Subject: AP1000 Responses to Requests for Additional Information (SRP3)

RAI-SRP3.7.1-SEB1-02 R2

AP1000 TECHNICAL REPORT REVIEW

RAI Response Number: RAI-SRP3.7.1-SEB1-02

Figure 1.0-1: Comparison of the HRHF horizontal input spectra to the CSDRS

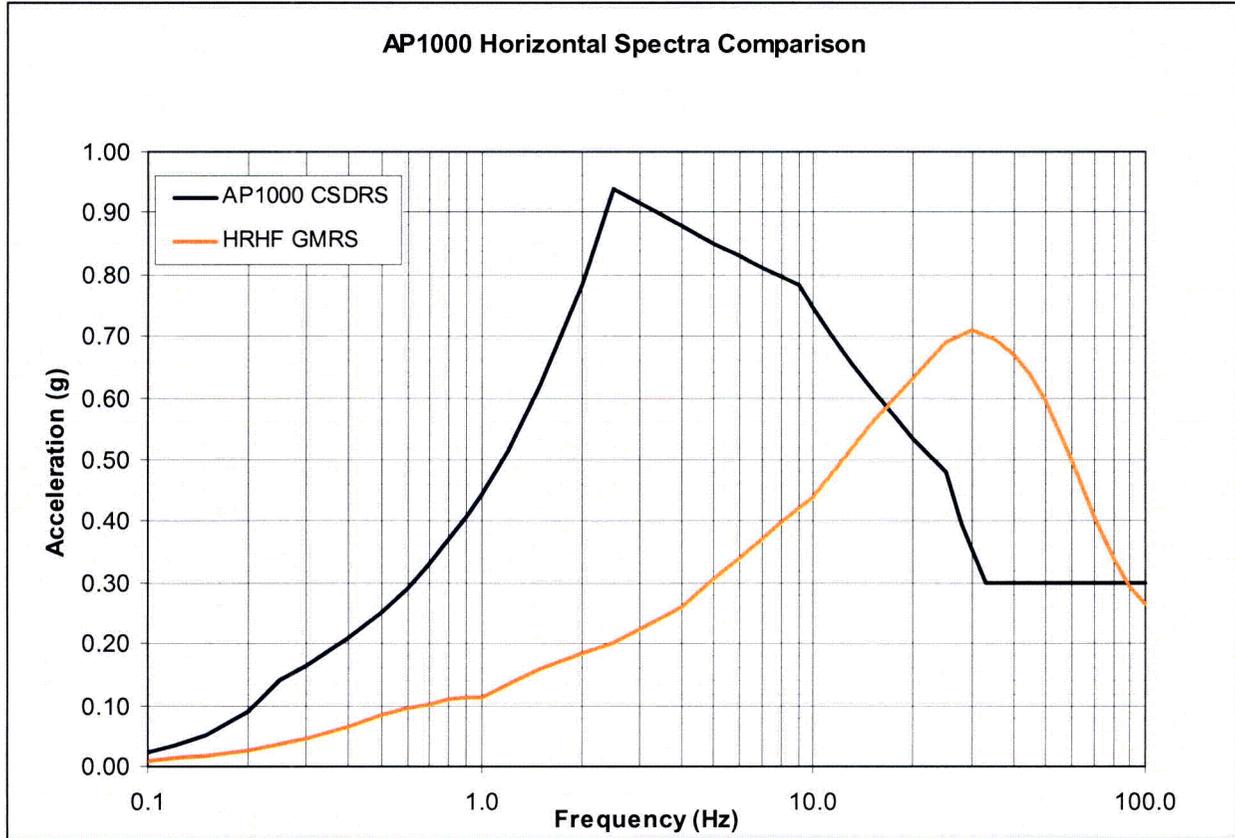
Modify Figures 1.0-1 and 1.0-2 to be consistent with Figures 5.0-3 and 5.0-4 given in TR-144.

- b) HRHF shear wave velocity profile is shown in Table RAI-SRP3.7.1-SEB1-02-1.
- c) Two horizontal and one vertical synthesized time history was generated which enveloped the HRHF GMRS shown below in Figure 1.0-1 and Figure 1.0-2 under the section titled "Technical Report (TR) Revision." The HRHF GMRS time histories are applied at NI foundation level of 60.5 ft. HRHF GMRS and FIRS are identical for the HRHF sites.

A Hard Rock High Frequency (HRHF) spectrum has been developed that envelopes three hard rock sites for which Combined License applications using the AP1000 as the vendor design are being prepared. Figures 1.0-1 and 1.0-2 compare the HRHF at foundation level against the AP1000 CSDRS for both the horizontal and vertical directions for 5% damping. The HRHF exceeds the CSDRS for frequencies above about 15 Hz. Evaluations in this report ~~describe the seismic input at a hard rock site where the nuclear island is founded on hard rock~~ are for Ground Motion Response Spectra (GMRS) with high frequency input.
